Recall Campaign Bulletin

Campaign No. 2021120016,
December 28th, 2021

SUBJECT: **Model CLA-Class (118 platform)**
Model Year 2020

Check the Power Steering Supply Connection

**Figure 1**

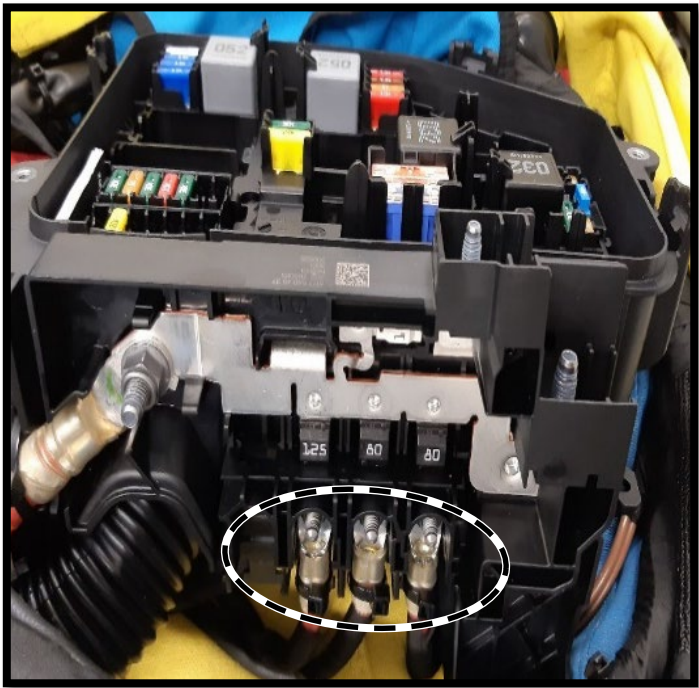
1. Disconnect ground line of battery (**AR54.10-P-0003MFA**).
2. Remove cover from fuse box/prefuse box at front.
i For basic data, see **AR54.15-P-1330MFA**.
3. Remove cable ties and loosen all threaded connections individually in succession on prefuse box (marking, **figure 1**)
i Depending on the equipment variant, there may be more or fewer cables present (marking, **figure 1**).
